# PREVOST

## IS-96157A

### DOOR UPPER LATCH ASSEMBLY - REPLACEMENT OF SINGLE ACTION CYLINDER WITH DOUBLE ACTION CYLINDER FOR H3-40, H3-41 AND H3-45 COACHES

FIGURE 3: NEW UPPER LATCH INSTALLATION

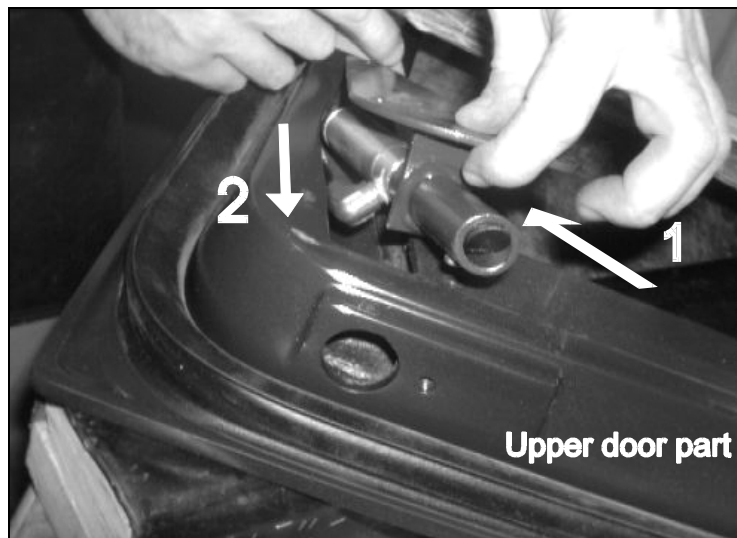
3. Connect pneumatic tubes to upper latch (older tube to end of upper latch end and new tube to 90 elbow).
4. Insert new latch bottom end first, rotate and rise in position as shown on figure 3.

FIGURE 4: NEW LATCH ACTUATING VALVE

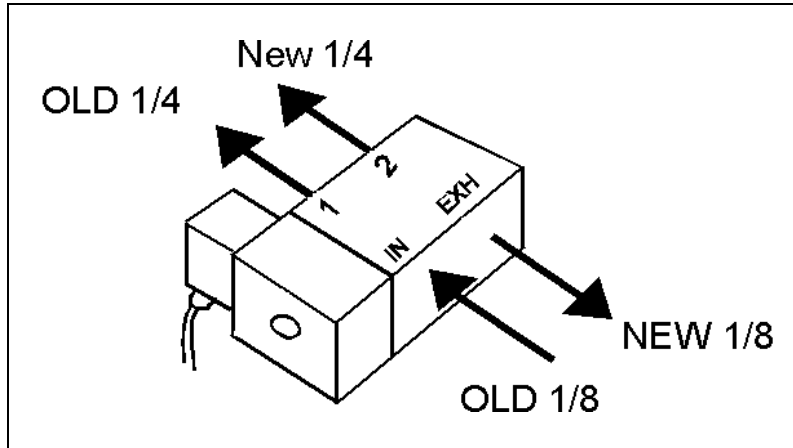
- 
5. Secure latch in place with screws.
  6. Remove latch actuating valve (near wiper motor). This valve is a three-way-valve and is similar to the one supplied in the kit.
  7. Install new latching valve (Prévost #285468) using one of the old screws.

8. Connect (1/8"dia) tube to "IN", new (1/8"dia) tube to "EXH", old (1/4"dia) tube on "1" and new (1/4"dia) tube on "2" as shown in figure 4.
9. Reconnect solenoid wires.
10. Reinstall plate, wiring cover, ramp and front finishing panels.
